MEMORANDUM

To: Craig M. Failor – Oak Park Village Planner
From: Floyd D. Anderson & Rich Van Zeyl
Date: 9/5/2018 – Revised
Subject: 801 S. Oak Park Avenue – The Community Builders

The purpose of this memo is to review the revised design for the proposed project at 801 S. Oak Park Avenue. Wight & Co. previously reviewed this project and issued a memo on July 3, 2018 based on the pre-application drawings and meetings with the architect and developer. Revisions to the design were made and included in the Planned Development Application (No: PC-18-07), which serve as the basis for this updated memo.

A1.1 - Proposed Ground Floor Plan

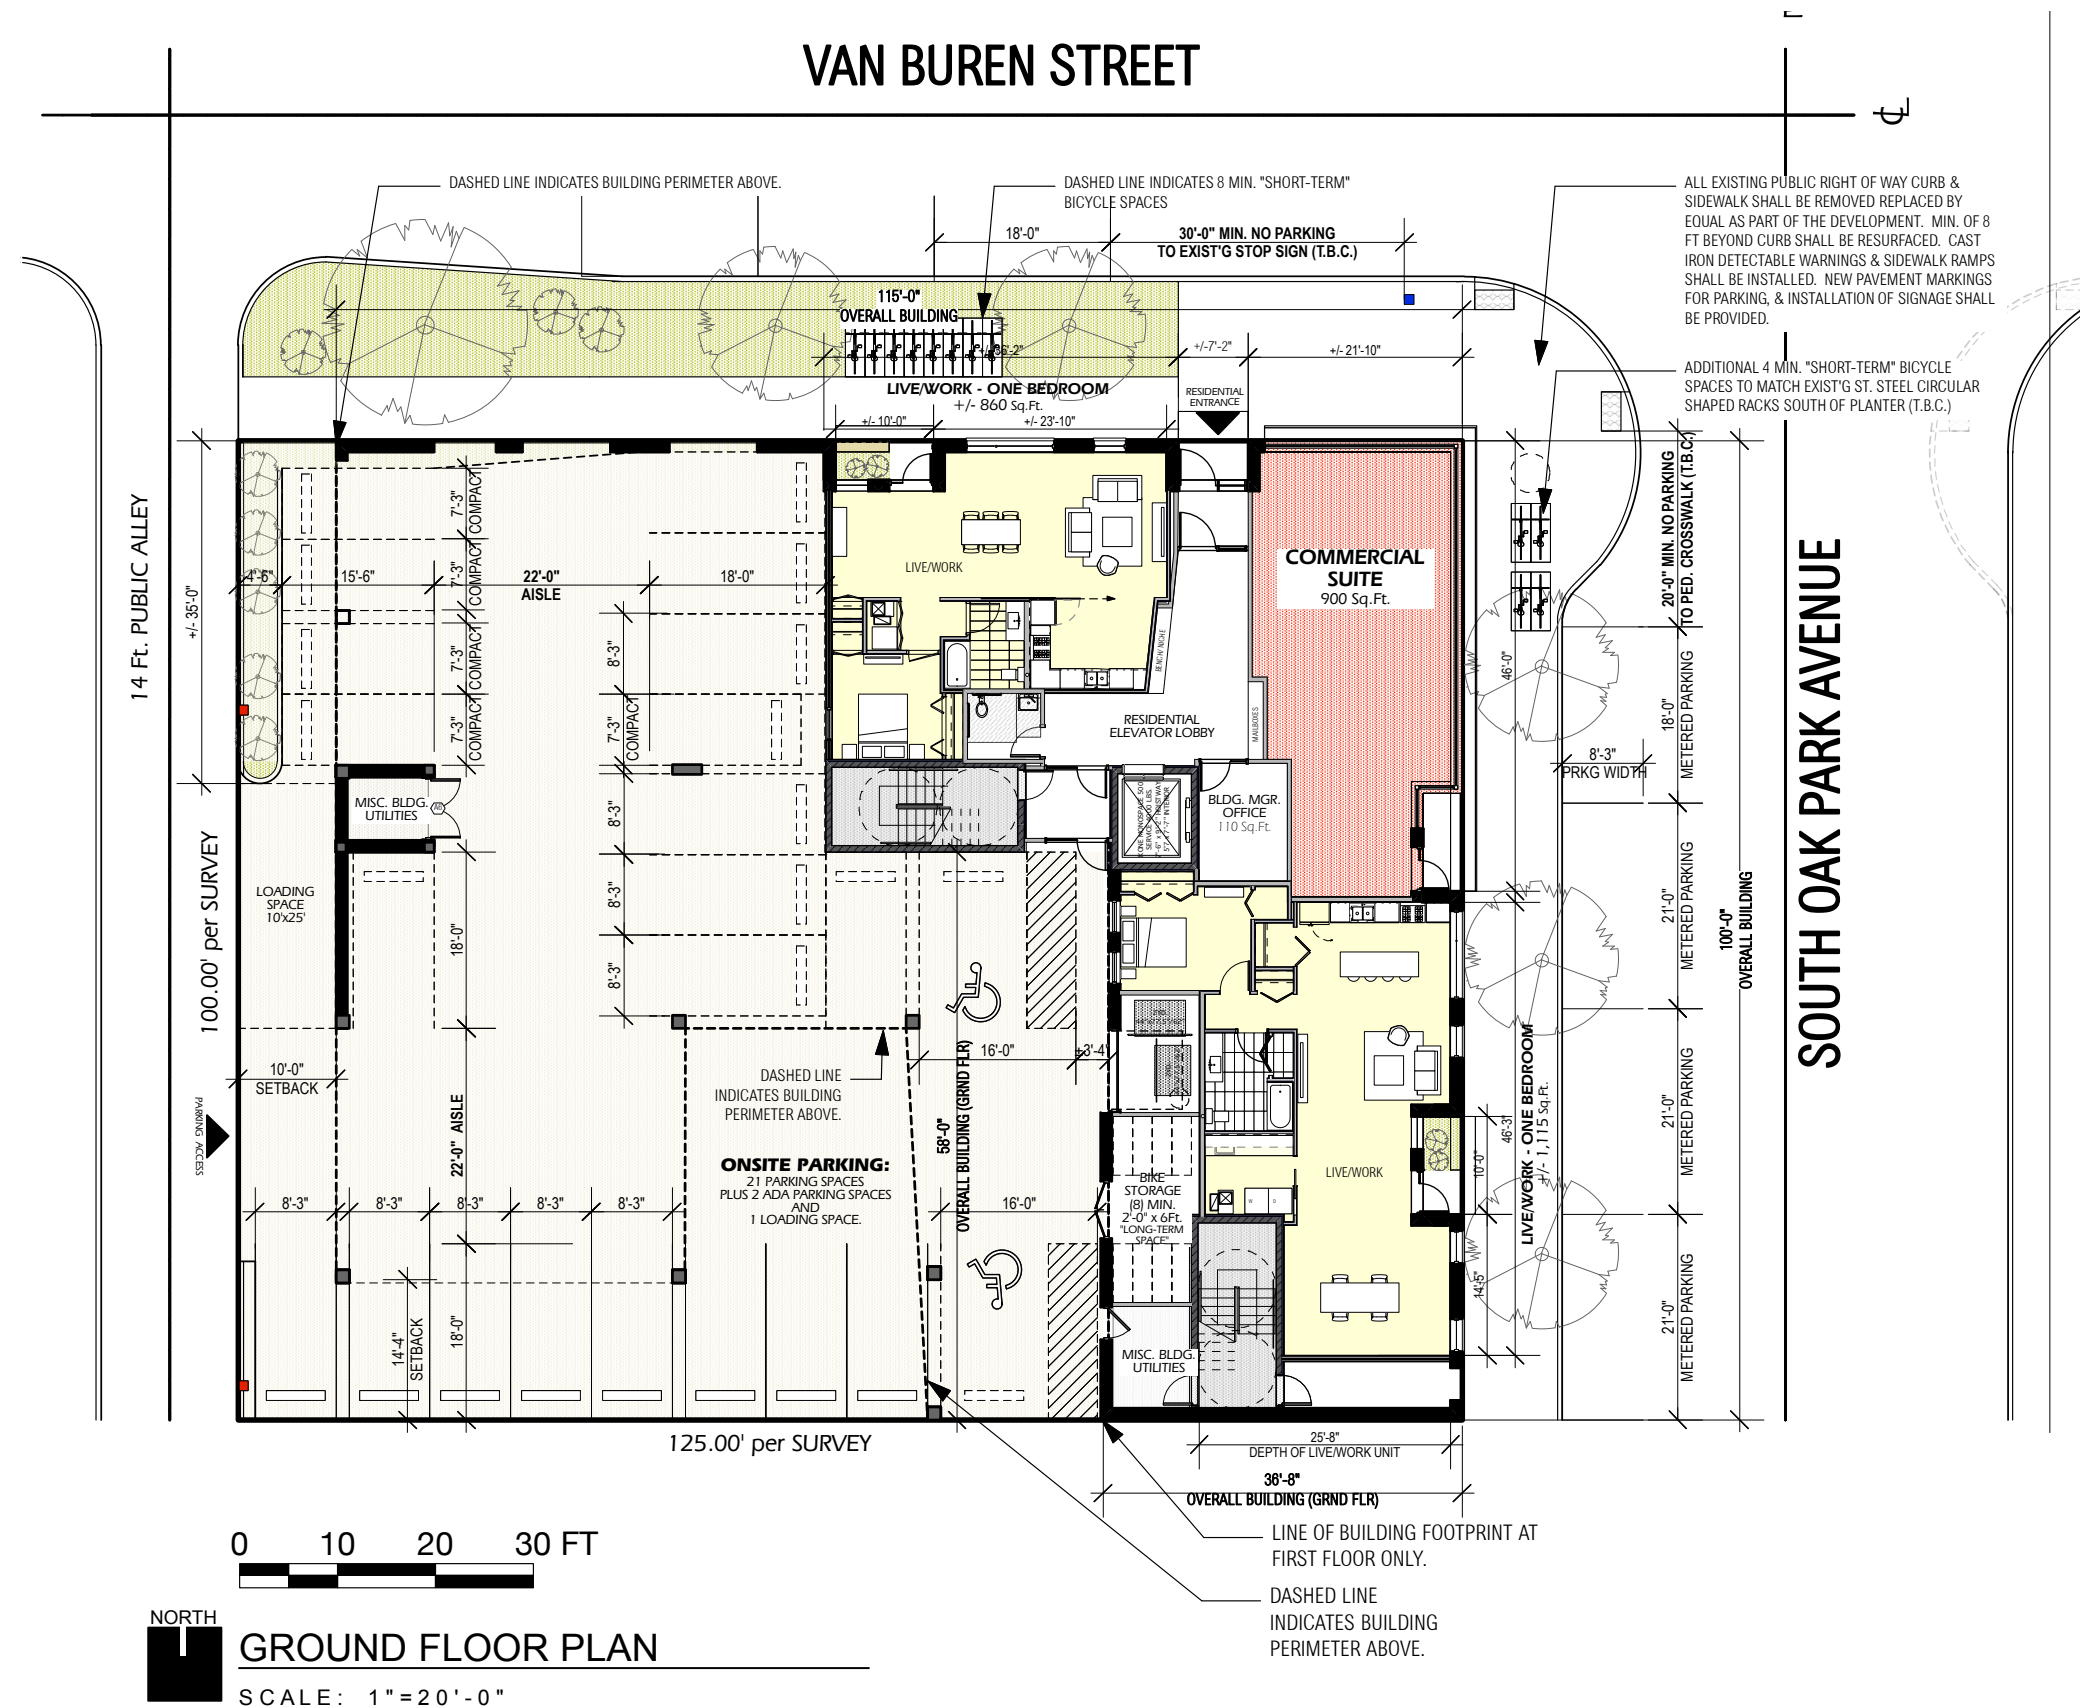
- b) The recessed niches for the Live/Work units at the Ground Floor have what appears to be some grillage(?) and possible a planter(?). These design elements are probably fine but are

- not depicted well in the drawings and perspectives. We'd like to understand the design intent better.
- c) We assume the corner Commercial Suite will need some structural columns to support the upper floors. These are not shown in the plans or the perspectives. We'd like to understand the design intent better.
 - d) There is a discrepancy between the elevations and the perspectives regarding the size of the Ground Floor windows. The perspectives show brick above the windows, below a horizontal brick band course. The elevations indicate the window head just under the brick band.
 - e) All materials are not indicated such as the brick band referenced above or the base band at the Ground Floor.
 - f) There are some miscellaneous vertical and horizontal lines shown on the elevations but not called out. Are these expansion joints or flashing or what?

A4b - Proposed Exterior Elevations (with Material Notes)

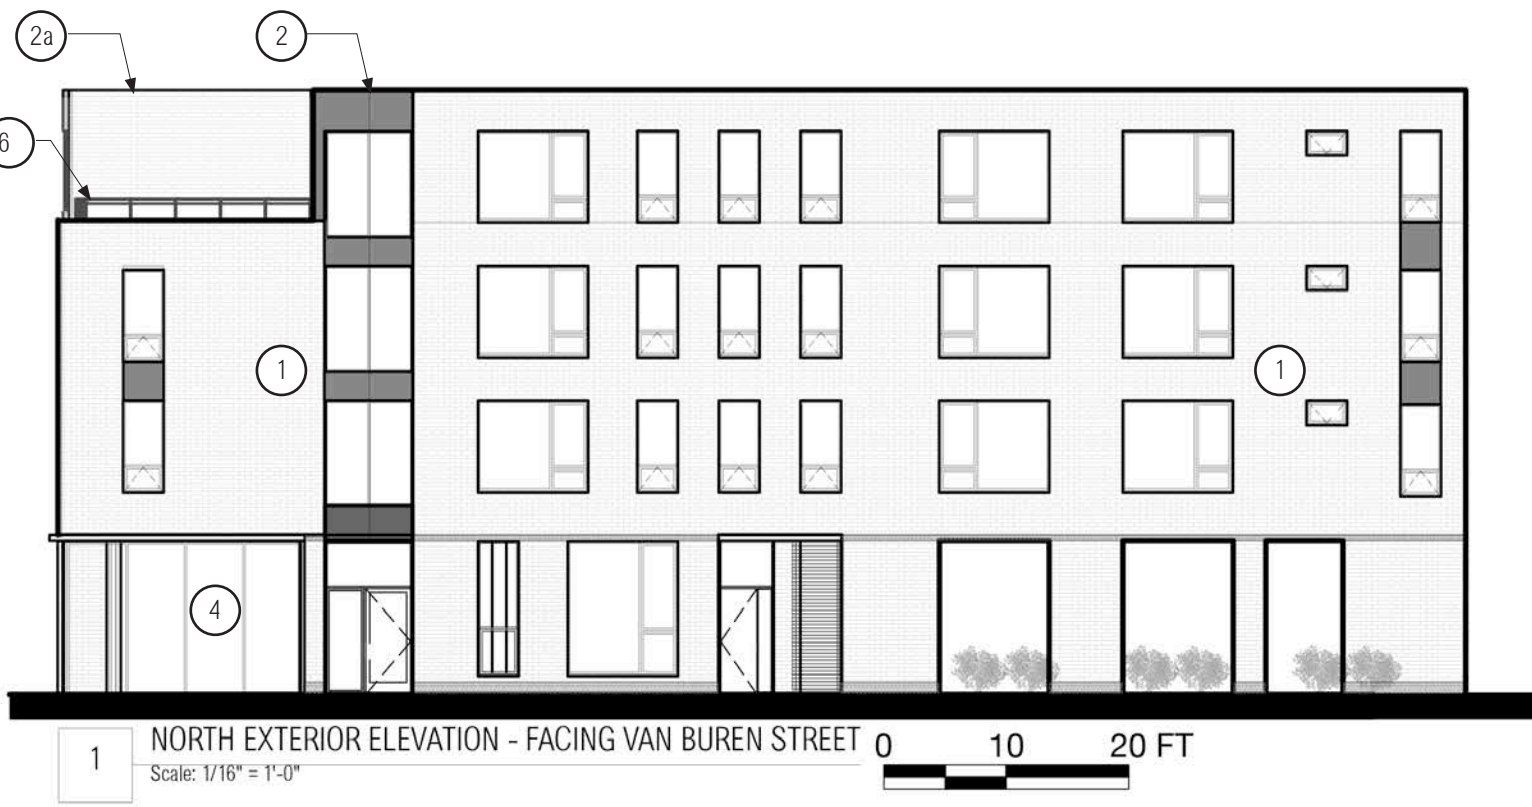
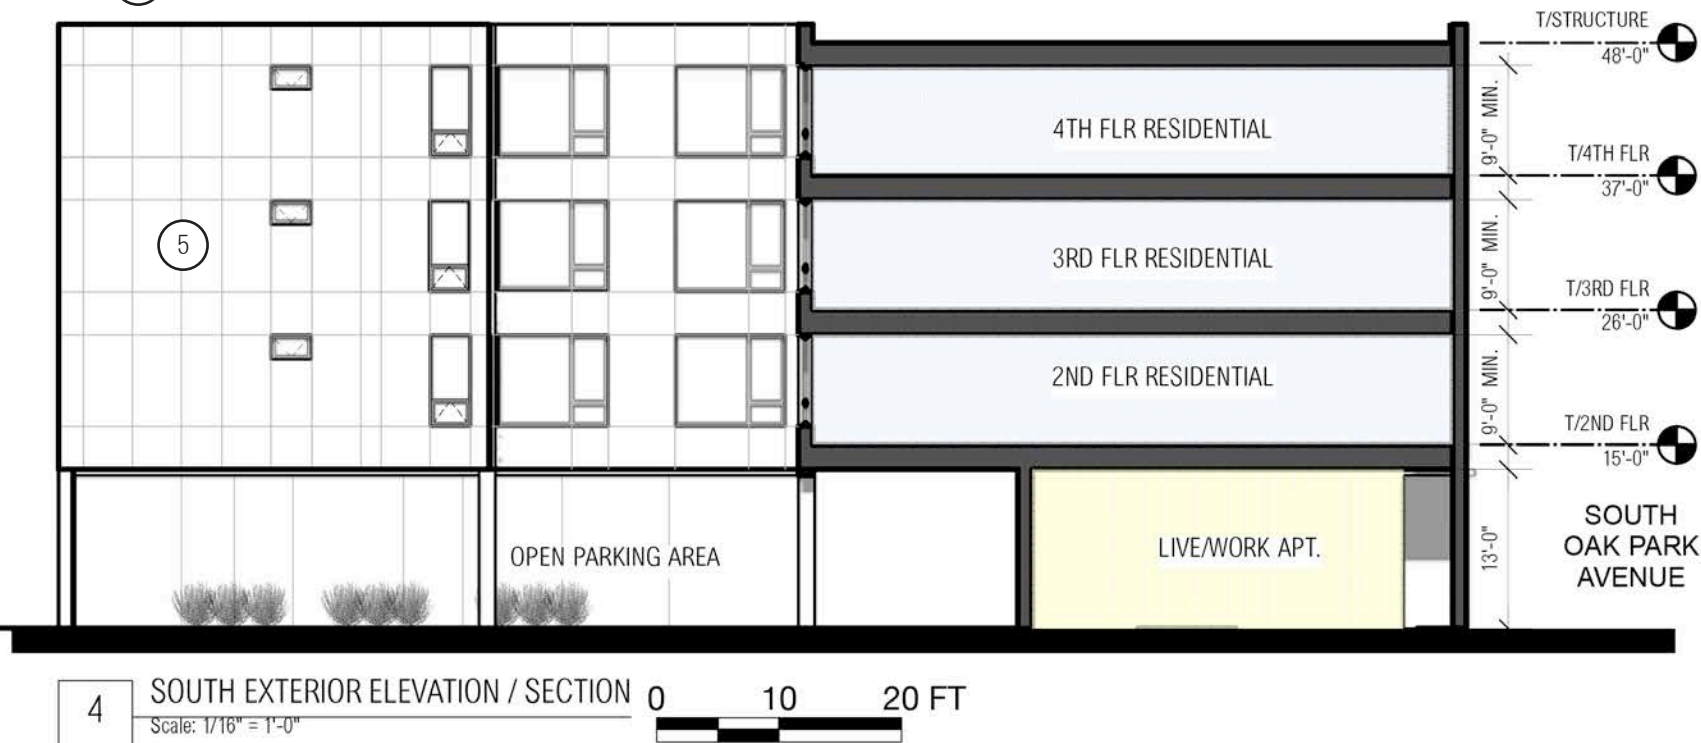
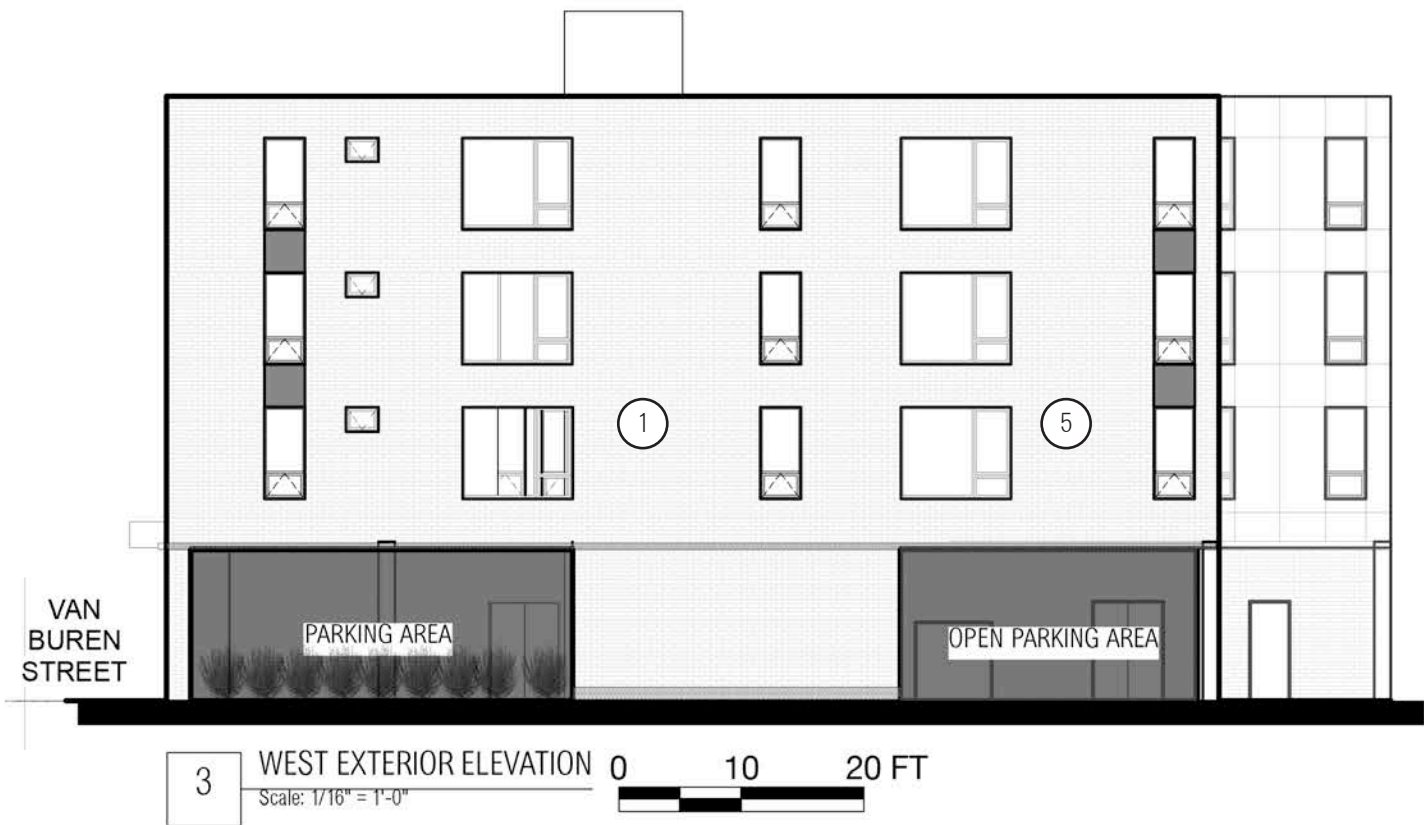
3. Regarding the elevations, we have a number of comments;
 - a) On the S. Oak Park façade there is an open exit corridor from an internal stair that should probably have a gate or door added. Its present design may be a security hazard as well as a collector of trash.
